[Docket No. NHTSA-2007-28517]

Federal Motor Vehicle Safety Standards; Electric-Powered Vehicles: Electrolyte Spillage and Electrical Shock Protection

ACTION: Notice of proposed rulemaking (NPRM).

Figure 1. S7.6.6 Measurement of High Voltage Source for Vb Voltage

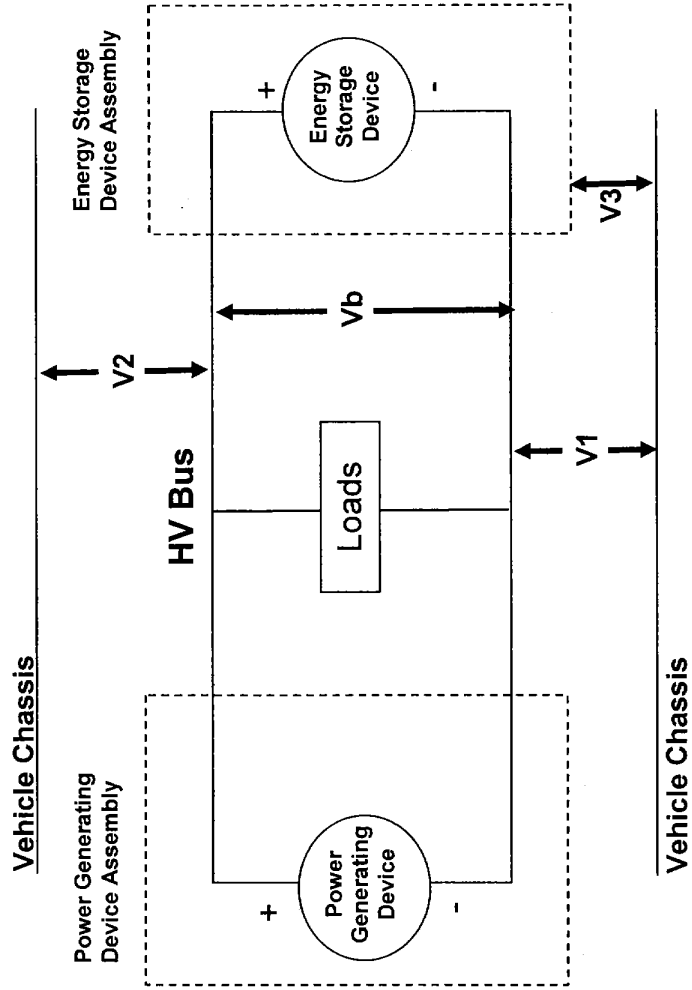
S7.6.3 The voltage(s) is/are measured as shown in Figure 1 and the high-voltage source voltage(s) (Vb) is/are recorded. Before any vehicle impact test, Vb is equal to or greater than the nominal operating voltage as specified by the vehicle manufacturer.

Figure 2. S7.6.4 Measurement for V1 Voltage between the Negative Side of the High Voltage Source and the Vehicle Chassis

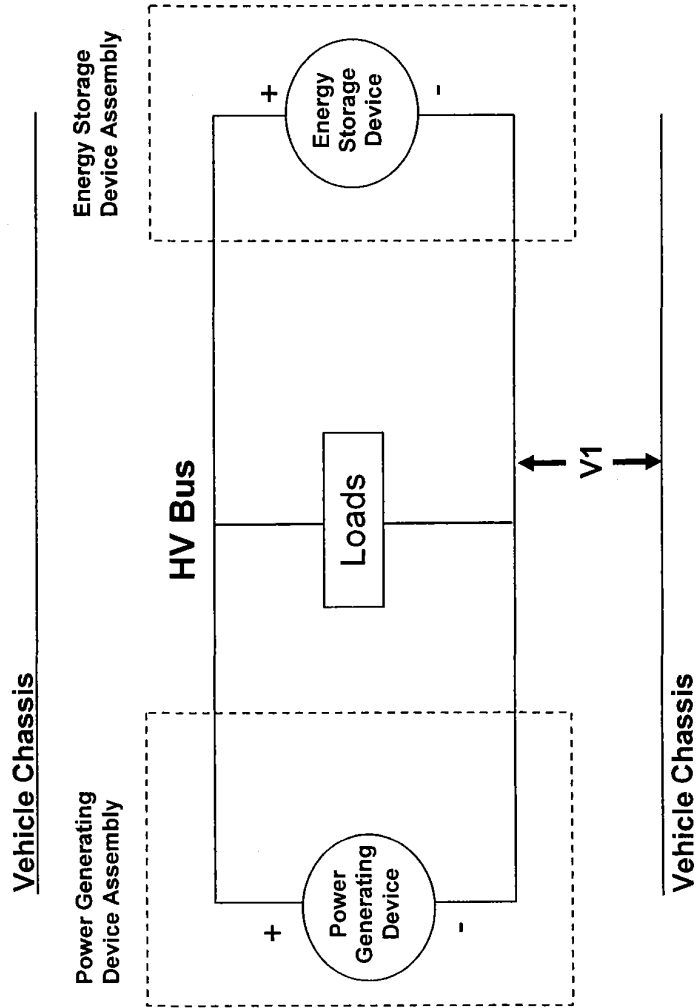
S7.6.4 The voltage(s) is/are measured as shown in Figure 2, and the voltage(s) (V1) between the negative side of the high-voltage source and the vehicle chassis is/are recorded.

Figure 3. S7.6.5 Measurement for V2 Voltage between the Positive Side of the High Voltage Source and the Vehicle Chassis

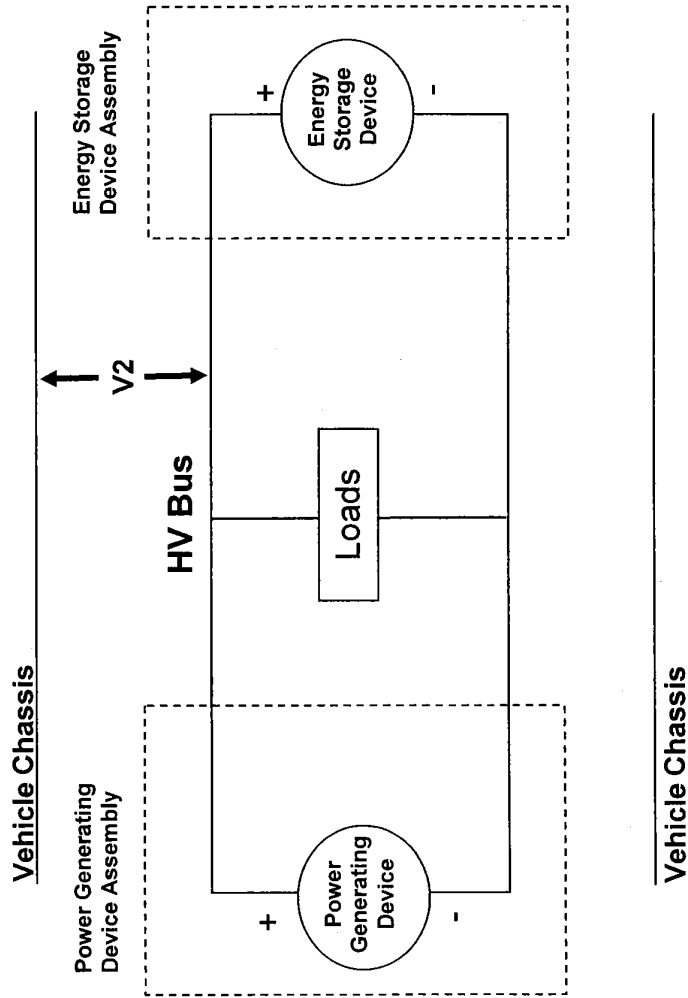
S7.6.5 The voltage(s) is/are measured as shown in Figure 3, and the voltage(s) (V2) between the positive side of the high-voltage source and the vehicle chassis is/are recorded.

Figure 4. S7.6.6 Measurement for V_1' Voltage across Resistor between Negative Side of the High Voltage Source and Vehicle Chassis

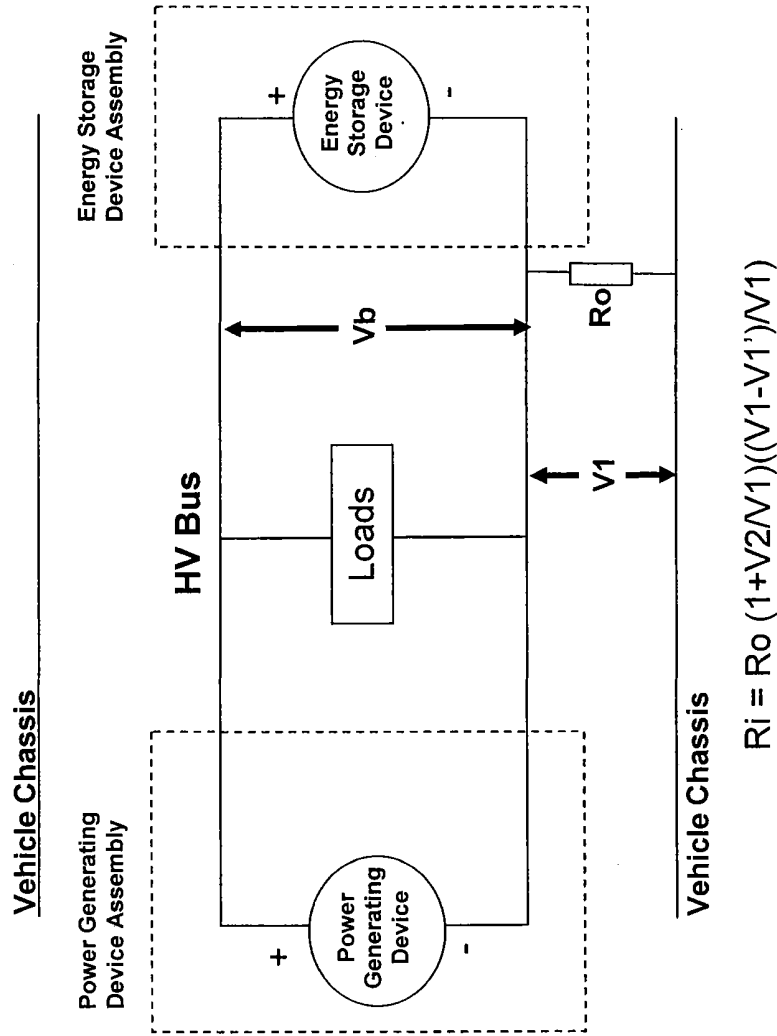
S7.6.6 If V1 is greater than or equal to V2, insert a known resistance (Ro) between the negative side of the high-voltage source and the vehicle chassis. With the Ro installed, measure the voltage (V1') as shown in Figure 4 between the negative side of the high-voltage source and the vehicle chassis. Calculate the electrical isolation (Ri) according to the formula shown.

Figure 5. S7.6.7 Measurement for V2' Voltage across Resistor between Positive Side of the High Voltage Source and Vehicle Chassis

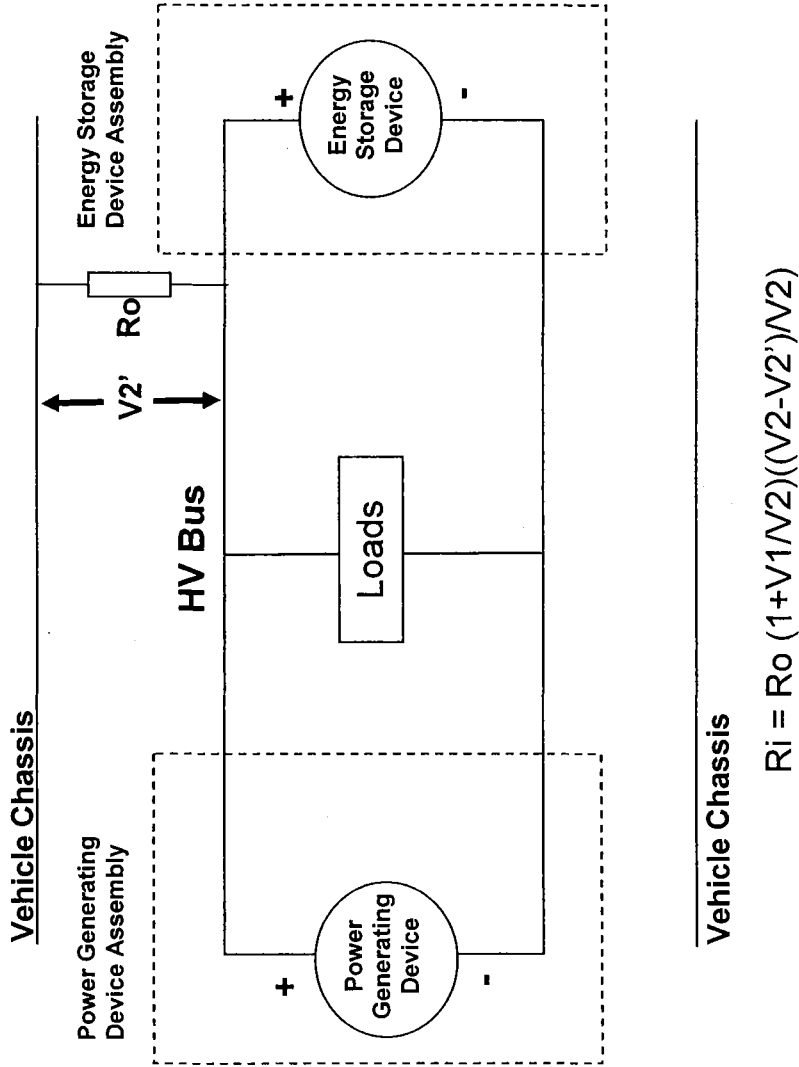
S7.6.7 If V2 is greater than V1, insert a known resistance (Ro) between the positive side of the high-voltage source and the vehicle chassis. With the Ro installed, measure the voltage and record the voltage (V2') between the positive side of the high-voltage source and the vehicle chassis as shown in Figure 5. Calculate the electrical isolation (Ri) according to the formula shown.
